City of Hutto

Planning and Zoning Commission

Tuesday, June 6, 2023 at 7:00 PM

RE: Lidell Walker Phase 1 Final Plat, Hutto, TX 78634
Final Plat Review – Lidell Walker Phase 1 Final Plat - Comment Report to Update #1 Submittal (received 5-8-23)
Project No.: 2057-PLAT

HEC-RAS Plan: Ult_v1 River: Mustang Creek Tr Reach: FLOWLINE Profile: PF 1

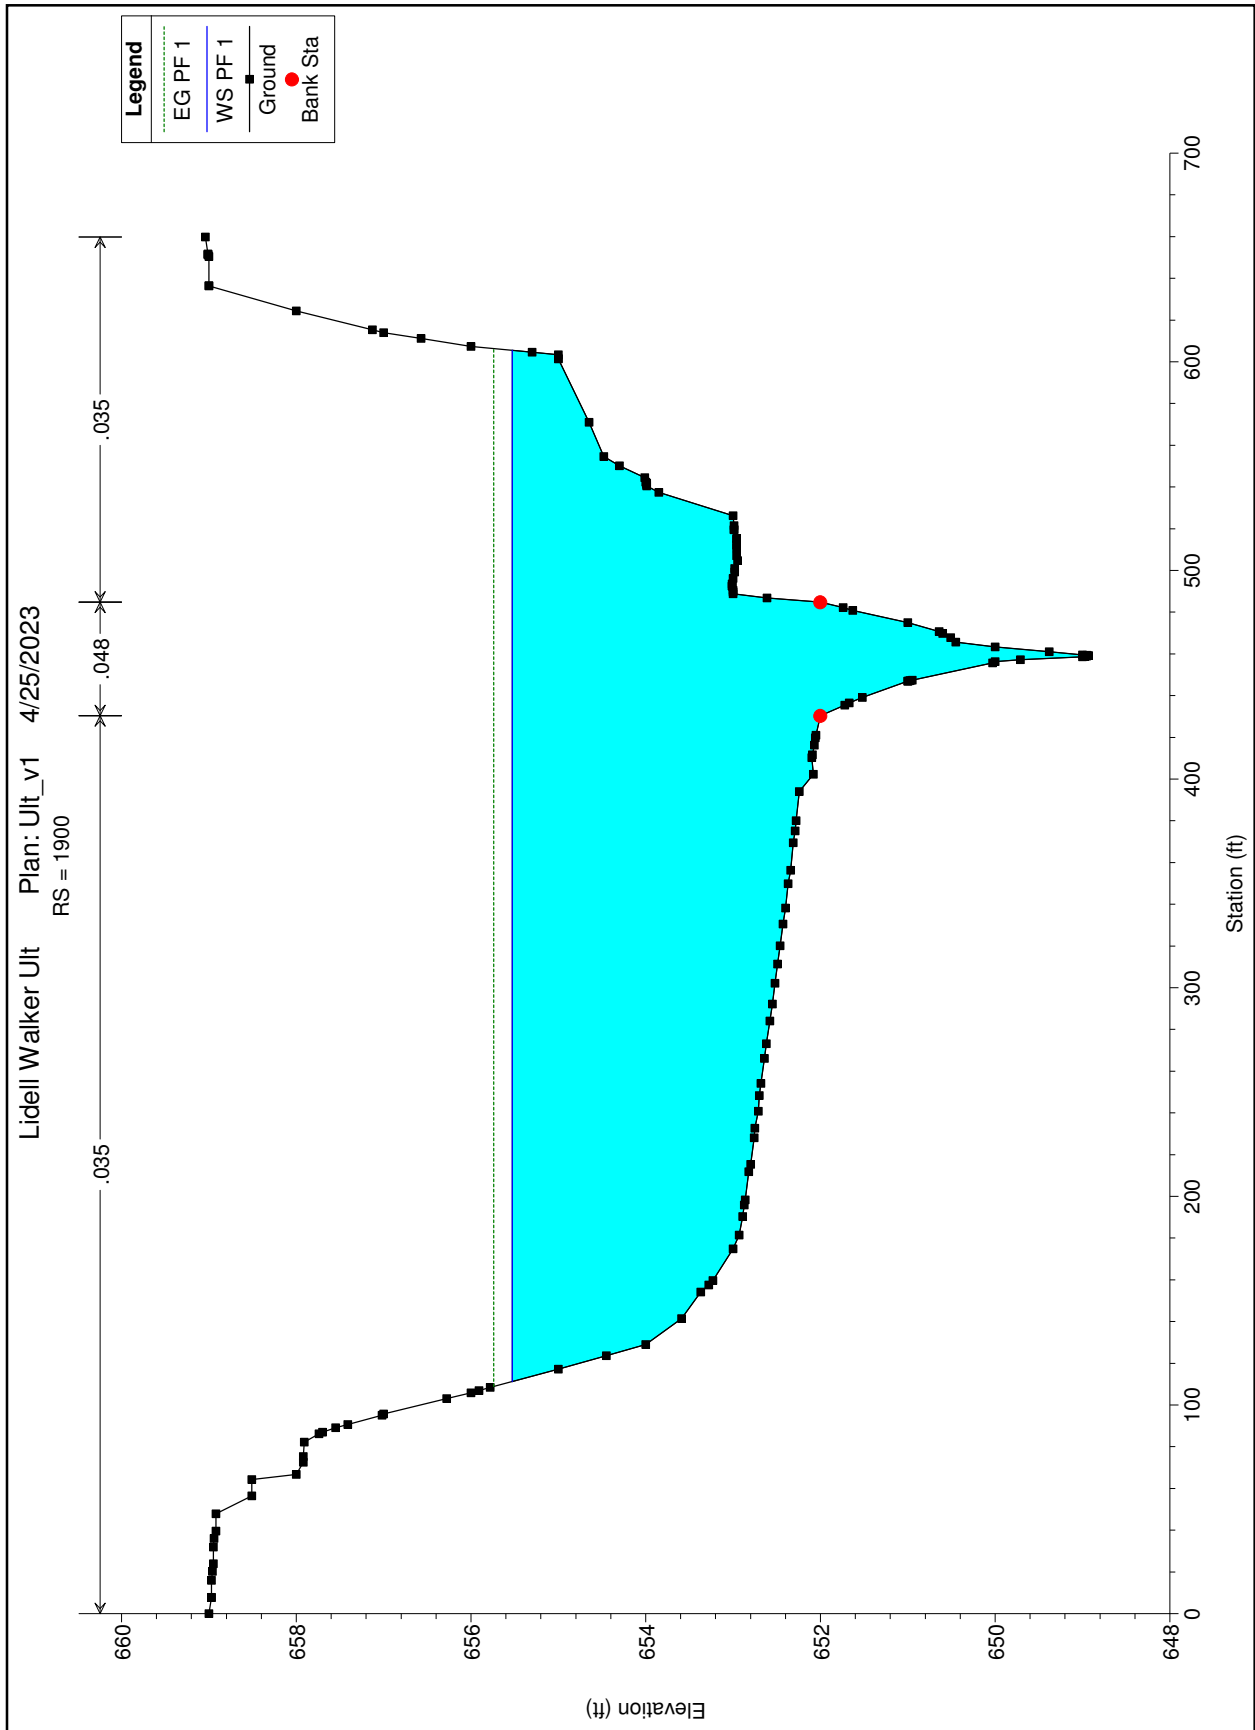
per the DA maps
there should be flow
changes at stations
200, 800, 1300, and
1800.
Per the HMS analysis
the final flow should
be 4827.60.
